**Re: GE-Pittsfield/Housatonic River Site
Newell Street Area II (GECD450)
Response to EPA's April 21, 2003 Conditional Approval Letter for the Pre-Design
Investigation Report**

**RESPONSE TO EPA'S APRIL 2003 CONDITIONAL APPROVAL LETTER FOR THE NEWELL STREET AREA II PRE-DESIGN INVESTIGATION REPORT
GENERAL ELECTRIC COMPANY - PITTSFIELD, MASSACHUSETTS**

FIGURE
8

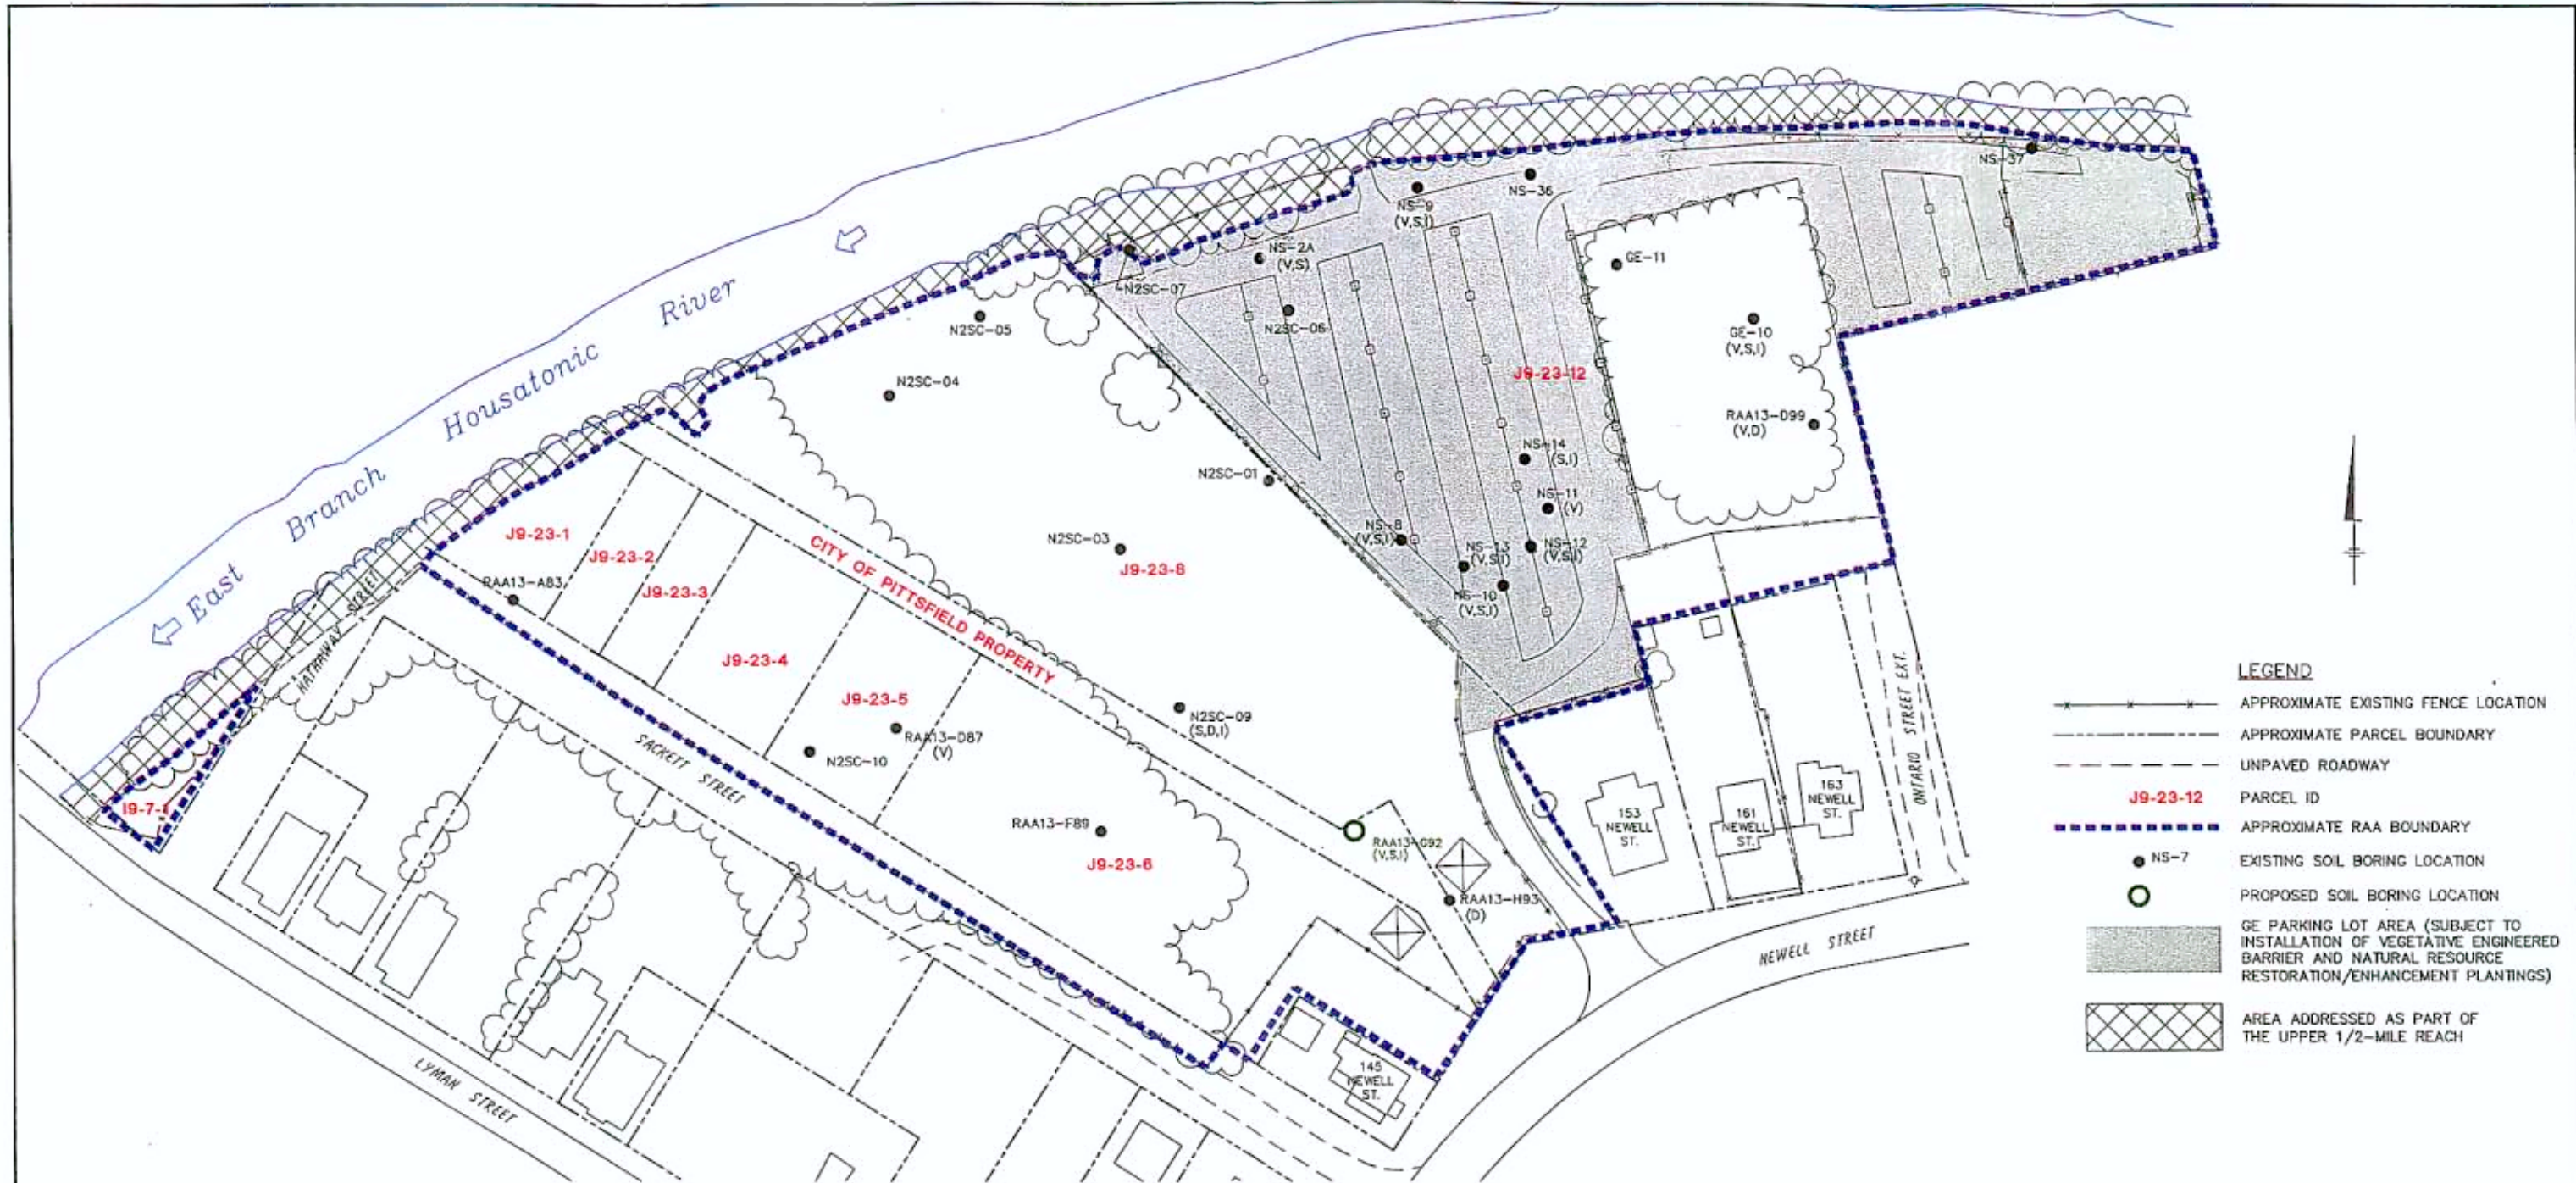
1. In Condition 1 of its April 21 letter, EPA directed GE to ensure that the proposed sampling at locations RAA13-C88 and RAA13-Z90, which is intended to better characterize the PCBs in the soils for utility bands associated with the 20-inch and 48-inch sewer lines, will extend vertically to represent the depth of the bottom of the utility trench bedding material. GE subsequently contacted the City of Pittsfield Engineer who indicated that utility trench bedding can extend two feet below the invert of the utility pipe. To assure adequate coverage for the 20-inch sewer line to include the depth to utility bedding material, GE will extend the boring depth at RAA13-C88 from seven feet to nine feet, and soil samples will be collected from the 1- to 3-foot, 3- to 6-foot and 6- to 9-foot depth increments for analysis of PCBs. For the 48-inch sewer line and for the same reason described above, the soil boring at sample location RAA13-Z90 will be extended to a depth of 15 feet (instead of the originally proposed 12 feet), and soil samples will be collected from the 1- to 3-foot, 3- to 6-foot, 6- to 10-foot, and 10- to 15-foot depth increments for analysis of PCBs.

Table 1, attached to this letter, reflects the revised scope of supplemental pre-design sampling, showing the supplemental sampling locations, depths, and analyses identified in the PDI Report with the changes described above. Additionally, revised Figures 4 through 8 illustrate the currently proposed supplemental Appendix IX+3 sampling locations, along with the existing Appendix IX+3 soil sample locations from investigations previously performed either as part of or prior to the pre-design investigations. Except as noted in this letter, the procedures and methodologies described in the PDI Report for the supplemental sampling activities will remain unchanged.

1. In its Condition 3, EPA directed GE to clarify and illustrate the extent of the proposed vegetative engineered barrier in the GE parking lot area. In response, the currently anticipated extent of that barrier is identified on Figures 4 through 8 with gray shading. Following completion of the remaining pre-design soil investigations, as well as the detailed survey described in the PDI Report, GE will, as part of future RD/RA activities, more specifically delineate the area to be subject to the barrier.

3. In Condition 5 of its letter, EPA provided comments on some of the tables and figures in the PDI Report and directed GE to make certain changes or clarifications to those tables and figures. GE will make those changes, as appropriate, in the tables and figures to be included in the forthcoming Supplemental Pre-Design Investigation Report (Supplemental PDI Report) described below. In addition, in response to EPA's Comment 5.c, GE notes that all recreational parcels identified on Figure 2 of the PDI Report as "GE owned or in the process of purchasing" are now owned by GE. Finally, the changes that EPA requested to Figures 7 and 8 are also reflected on the revised figures attached to this letter.
